DOCUMENT 00 91 13  
ADDENDUM NO. 1

Lincoln County  
Killian Creek WWTP Upgrade Phase 3  
WKD Project Number #20170294.00.CL

ADDENDUM NUMBER NO. 1

March 11, 2020

GENERAL NOTES

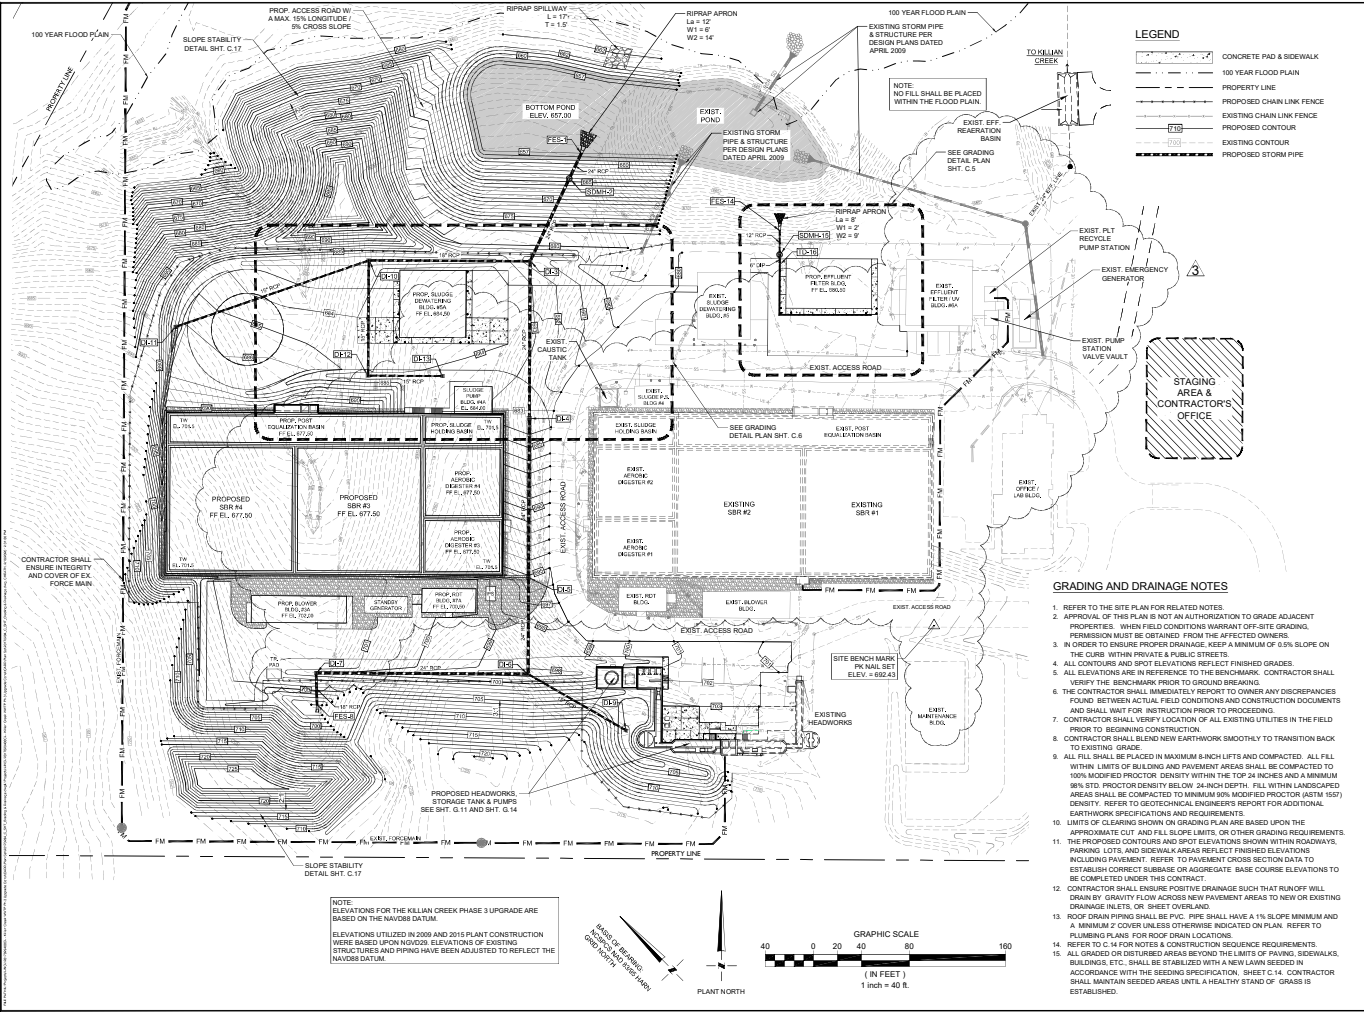
Item 2: Drawing S.0.1 – General Notes

DELETE Drawing S.0.1 in its entirety and REPLACE with the attached Drawing S.0.1., dated 2/12/20.

- B. REMOVE ALL Voids LARGER THAN 1 1/2" WIDE OR 1 1/2" DEEP.
  - C. REMOVE ALL PROJECTIONS LARGER THAN 1/2".
  - D. THE EDGES SHALL BE FINISHED.
12. AREAS EXPOSED TO VIEW (INCLUDING AREAS THAT WILL BE UNDER WATER INSIDE A TANK) SHALL HAVE A FORMWORK SURFACE FINISH -3.0 AS SHOWN IN ACI 308.

- A. PATCH ALL HOLES.
  - B. REMOVE ALL PROJECTIONS LARGER THAN 1/2".
  - C. PATCH ALL THE HOLES.
  - D. SURFACE IRREGULARITIES SHALL MEET CLASS A AS DEFINED IN ACI 117.

- G. FINISH FINISH SHALL BE COMPACTED WITH FINISH SAND OR FINISH SAND AS DEFINED IN ACI 308. ANY GROUP COMPRISED OF 3 PART CENTER AND 1.5 PART SAND WITH WATER TO A CONSISTENCY OF THICK PASTE. SOLID ABOUT INTO Voids AND REMOVE EXCESS GROUT.

13. PROVIDE A WOOD OR OTHER NON-POROUS SURFACE FOR FORMWORK AND LAYERS FOR EXPOSED AREAS. THIS WOOD OR FIBER SHALL BE THE STANDARD FOR ACCEPTANCE FOR THE PROJECT. IF COMPLETED CONCRETE DOES NOT MEET THE STANDARD, IT SHALL BE ACCEPTED UNTIL IT MEETS THE STANDARD.
